PARISH OF ASCENSION
OFFICE OF PLANNING AND DEVELOPMENT
PLANNING DEPARTMENT

Planning Commission Appeals Board
December 14, 2016 – 4:00 PM
Courthouse East, 2nd Floor, Council Meeting Room
Gonzales, Louisiana

MAJOR SUBDIVISION PRELIMINARY PLAT-APPEAL

RE: **Camellia Cove
Preliminary Plat Review**

WAIVERS REQUESTED:

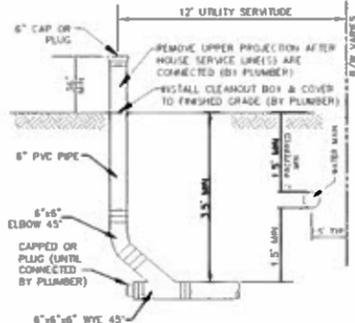
The block length waiver being requested on the west side of Oakbourne Ave. was discussed at the pre-application meeting and was requested due to the fact that this project is presented as a private subdivision, land use of the existing adjacent property to the west of the site and the unlikely possibility that a roadway would ever continue through to Hwy 928 (Bluff Road). A lot 'break' was proposed between lots 18 and 19 as Lot GS-3 to satisfy the ordinance. Staff required that notes be added to state that no obstructions would be placed on this lot and that, should the subdivision ever desire the streets go public, the HOA will provide the street connection to Oak Crossing Ave. on a roadway constructed to parish standards. Staff analysis is that this action satisfies the purpose of Table 'C'-Block Length of the Zoning Code.

Applicant is requesting a waiver on side setbacks from Table 'C' of the Zoning Code. The intent of table 'C' is to govern Major Subdivision Development and provide a variety of lot sizes and setback requirements for multiple product offerings within a subdivision. Table 'C' of the Zoning Code applies as the standard for Major Subdivisions and requires side setbacks according building classification and lot width. The typical 5' side setback for the RM classification of Zoning is to be applied for minor and individual lot

2. The waiver request ("Section 17-4038 for block length for west side of Oakbourne Ave") does not fall under the proper ordinance section and should be updated to reflect the correct section. **Consultant has provided.**

- Block length waiver is granted with stipulations on Lot GS-3 as noted.
- Waiver on side setbacks is denied. Should the denial of the setback requirements dictate a reduction in the number of lots, the revised plat can be approved at staff level.

TYPICAL STREET SECTION
N.T.S.

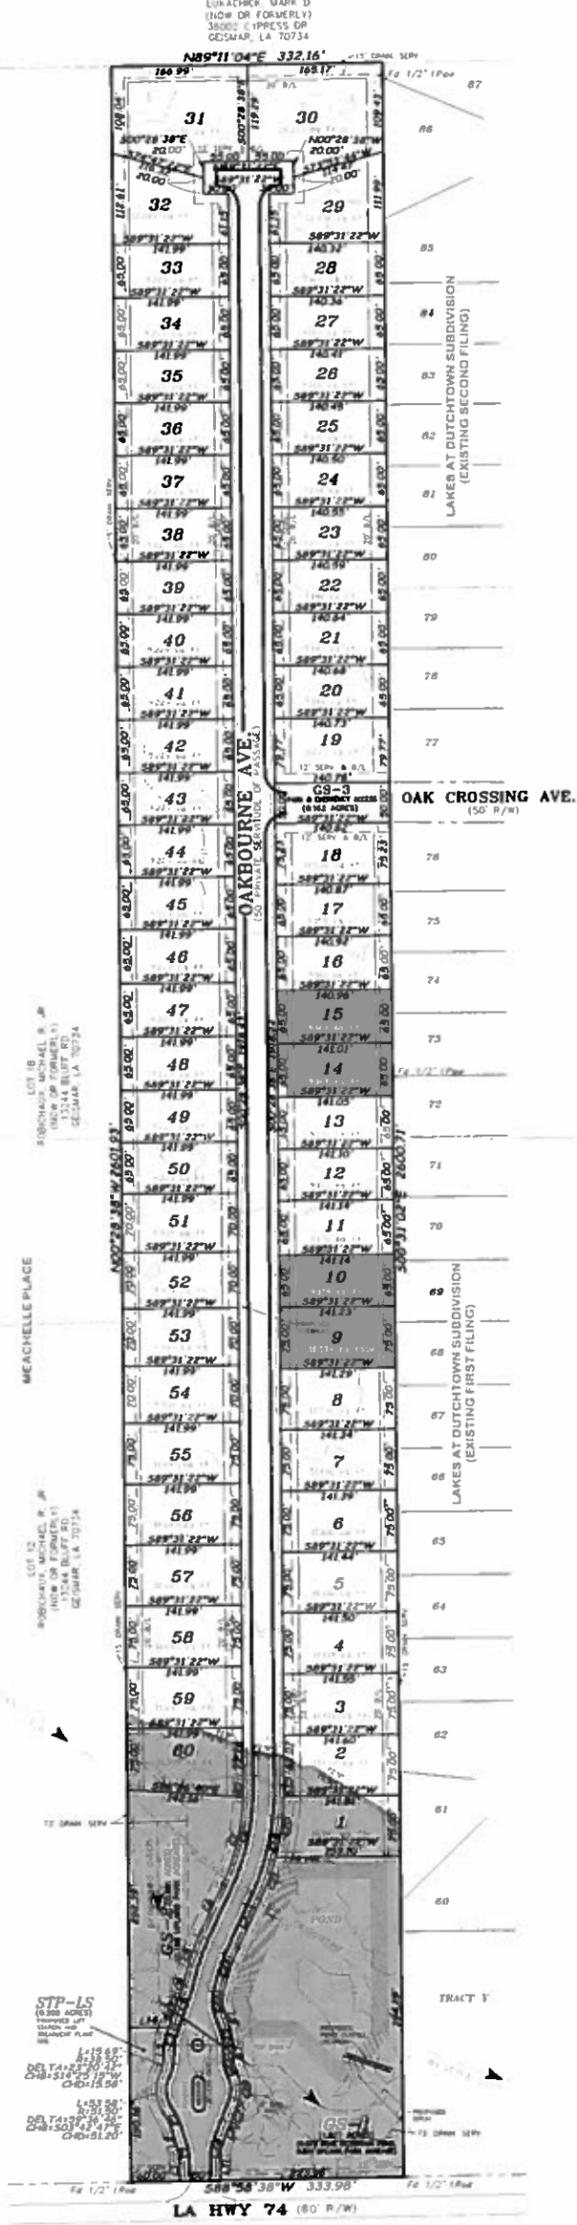
13. The side inlet drainage boxes on the typical section are to be precast instead of the currently depicted brick. **Consultant addressed this comment.**

14. Show the proposed sanitary sewer stacks with the typical street section. **Consultant has provided.**
15. Note the thickness of the asphalt and roadway base in the typical street section and ensure the specifications match the requirements for public roadways unless a variance is otherwise requested. **Consultant addressed this comment.**
